SERVICE BULLETIN SB-65

SUBJECT: Air Conditioning Duct Wiring

ROTORCRAFT AFFECTED: R44 II Helicopters thru S/N 12167 equipped with air conditioning.

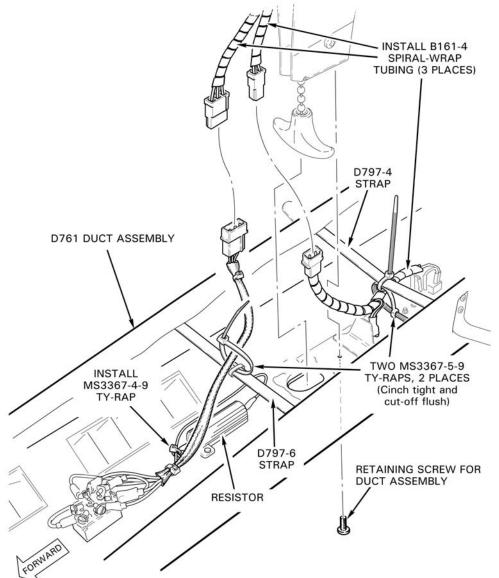
- **<u>TIME OF COMPLIANCE</u>**: Within next 100 flight hours or by 31 May 2008, whichever occurs first.
- **BACKGROUND:** RHC has received a report of an electrical short in the air conditioning wiring. The short was found in the A/C switch wires in the overhead duct assembly and was caused by the wires chafing against the aluminum support strap in the duct. Chafing occurred in the wiring between the aircraft headliner and connectors for the duct assembly. This Service Bulletin requires installing additional wire protection in two locations.

- 2. In duct assembly, remove and discard ty-raps securing wiring to D797 straps. Remove and discard ty-raps on map light and overhead light wires. Visually inspect wiring. Repair or replace any wires exhibiting insulation damage. Install an approximately 6-inch section of B161-4 (1/4-inch diameter) spiral wrap tubing over unprotected map light and overhead light wires in vicinity of D797-4 strap. Secure all wiring which might touch straps with ty-raps per figure on page 2.

- 1. Refer to figure on page 2. Remove D796-1 duct assembly by removing screw immediately aft of rotor brake knob assembly and sliding duct forward. Disconnect map light and air conditioning switch connectors. Thread rotor brake knob through bead-chain slot and remove duct assembly.

- 3. Visually inspect wiring between aircraft headliner and connectors for duct assembly. Repair or replace any wire exhibiting insulation damage. Remove and discard tyraps from wiring and install B161-4 spiral wrap tubing over as much exposed wire as practical.
